SERVICE BULLETIN

SUBJECT: NOISE SUPPRESSION IN HF RADIO EQUIPMENT GENERATED BY STROBE LIGHT.

S/B No. NMD-33-1
Page 3 of 4

FIG. 1

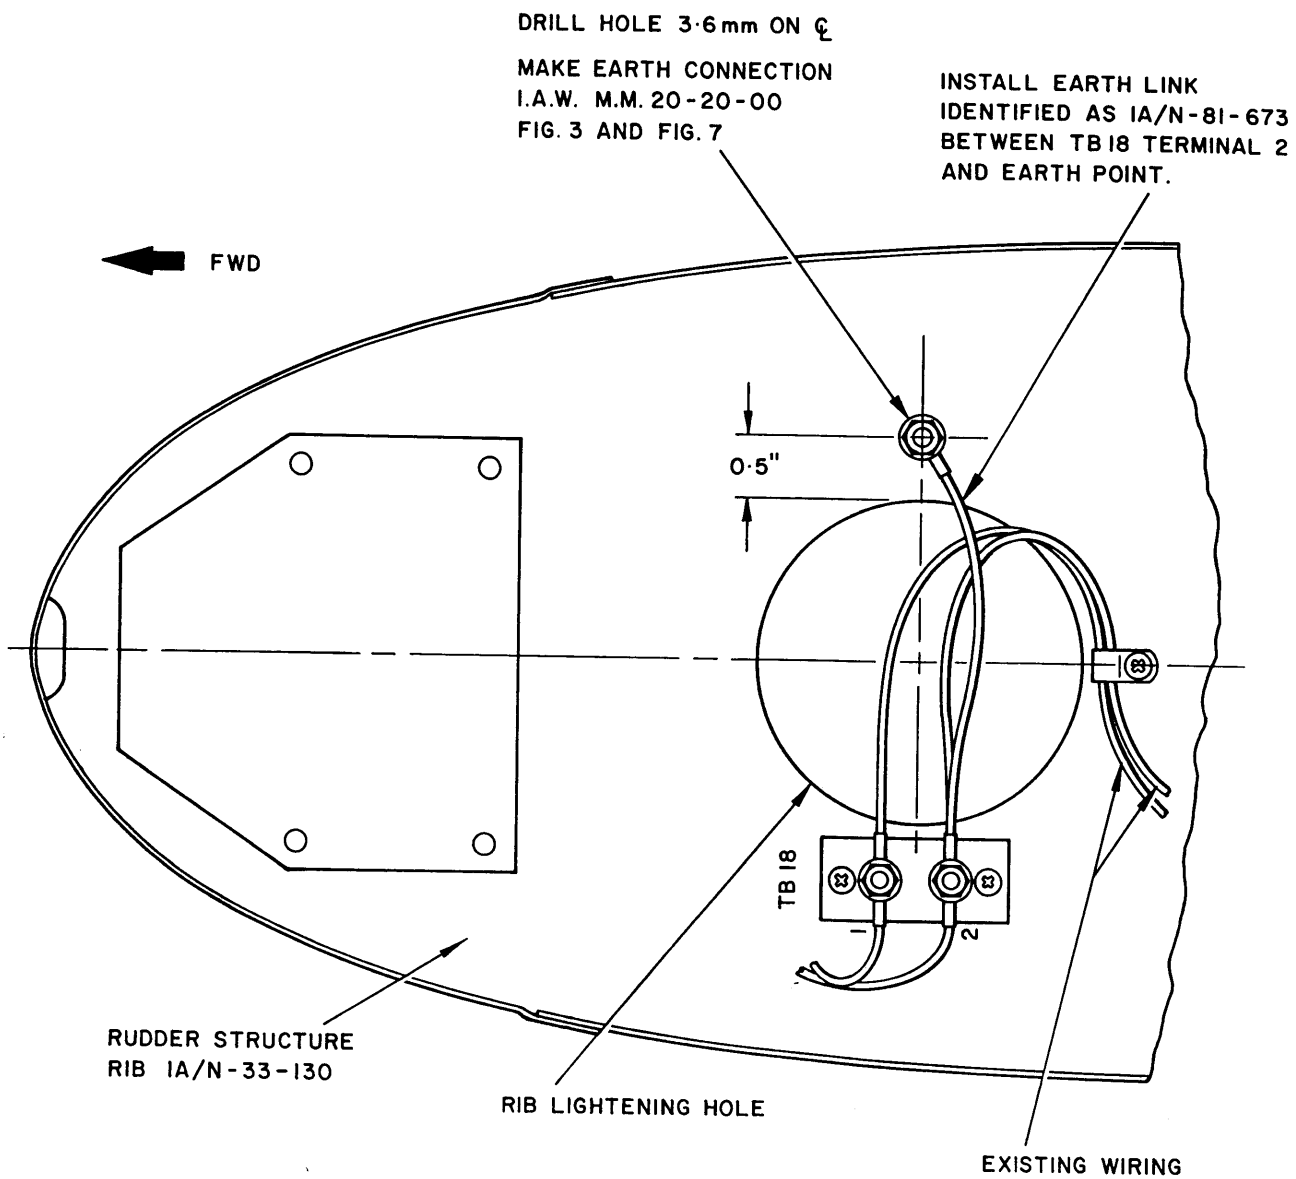
An earth connection is made at the strobe beacon on the rudder.

- (1) Remove strobe light beacon from rudder tip.
- (2) Ref. Fig. 1 of this instruction and manufacture 5" earth link cable from cable M81044-9-18-9, attach terminal lug MS25036-102 to each end. Identify link 1A/N-81-673.
- (3) Drill rudder structure rib in location as shown, for the earth connection.
- (4) Fit manufactured link 1A/N-81-673 between T.B. 18 terminal 2 and drilled hole in rib. Make earth connection as detailed in M.M. 20-20-00 Fig. 3 and 7 using earth bolt MS35206-229
nut MS21083
washer AN960-D6
washer MS35338-136
washer AN960-6
